Mask Set Differences Between the MPC5606BF and MPC5606BK

The 32-bit Qorivva Microcontroller Family

Document Number: AN4477

Figure 1. FMPLL clock source select via Auxiliary Clock Select 0

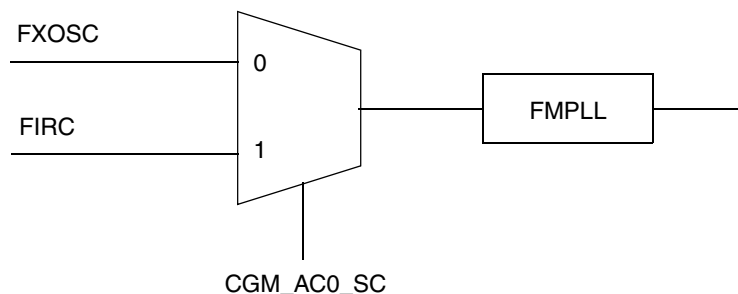
The MPC5606BK has an additional feature that makes it possible to use the PLL with a 16 MHz IRC source. On the MPC5606BF, the PLL can only be used with FXOSC as the source. For both devices, FXOSC remains the default clock source, so user software will have to activate this new feature on the MPC5606BK by setting auxiliary clock register bit CGM_AC0_SC.SELCTL and any other appropriate mode entry transition that is required.

It should be noted that this register is not present on the MPC5606BF. On the MPC5606BK, it is found at address 0xC3FE_0380 in the MC_CGM module's memory map. This address is reserved on the MPC5606BF.

The following points should be followed when utilising the PLL for MPC5606BK and MPC560xBF devices

1. Ensure PLL is disabled
2. Program ODF/IDF/NDIV
3. Ensure PLL selected as system clock source at mode entry mode configuration register
4. Enable PLL at mode entry mode configuration register (e.g. ME.DRUN_MC.R)

If the PLL frequency is required to be altered, ensure the PLL is turned off at mode entry configuration register, configure PLL settings (ODF/IDF/NDIV) and re-enable PLL. Moreover, It is possible to adjust ODF whilst PLL locked, but IDF and NDIV cannot be adjusted.
